**Yellowknives Dene First Nation - Information Request
Responses - Gahcho Kué Project Environmental Impact Review**

**GAHCHO KUÉ PROJECT ENVIRONMENTAL IMPACT STATEMENT
INFORMATION REQUEST RESPONSES**

Information Request Number: YKDFN_1.1

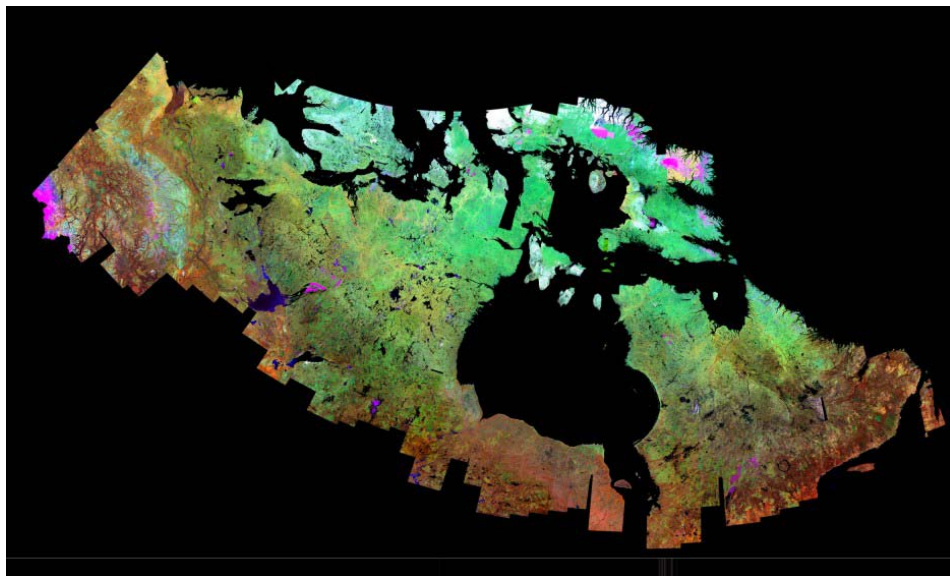
The proponent utilizes the Land Cover of Canada vegetation classification which has a 1 km resolution (pgs 7-83, 7-102) – the City of Yellowknife would be reduced to a few pixels, while Dettah is probably not detectable. This is a very low resolution basedata, which was then subjected to a modification process to resample it to a smaller resolution (down to 25-m resolution, then resampled to 200-m cell sizes (pg 7-83, 7-102). However, this does not improve the data, it simply slices the larger squares into smaller squares of the same value. Utilizing this data is only appropriate if the larger cells do a good job at approximating the actual landcover on the ground.

There are several high resolution datasets available for parts of the territory and from industrial projects in this extent. The creation of a unified legend/classification scheme would allow a comparison between the areas classified in the Land Cover of Canada and the higher resolution datasets, providing some indicator of the relative quality and confidence that the parties should have in the basedata. YKDFN have a real concern that the basedata used to complete the various analyses in the EIS may be producing results that will result in poor decisions and management as well as not assuring the Board or the Parties that the conclusions of no significant impacts are likely.

- 2) The proponent should provide a discussion why they chose not to use the 90 m (Extents found below) medium resolution Landcover of Canada (2005) or the 250m MODIS Landcover of Canada (2005) rather than a 1km version. These datasets would have provided a much improved picture of caribou use.

- 1) A comparison of the assessment database with a higher resolution dataset is not expected to change the impact predictions and determination of significance or reduce any uncertainty that may be linked to impact predictions for the following reasons.

Because the assessment approach emphasized relative changes across seasonal ranges through time, it is anticipated that “pixel size” would have limited influences on the amount of change in landscape measurement endpoints (e.g., habitat quantity and fragmentation, and habitat quality). In other words, the classification of the magnitude of impacts should be similar if another landscape classification is used. Related to this point, there is no reason to believe that the assessment outcome will change given the low level of development within the annual and seasonal ranges of the Bathurst
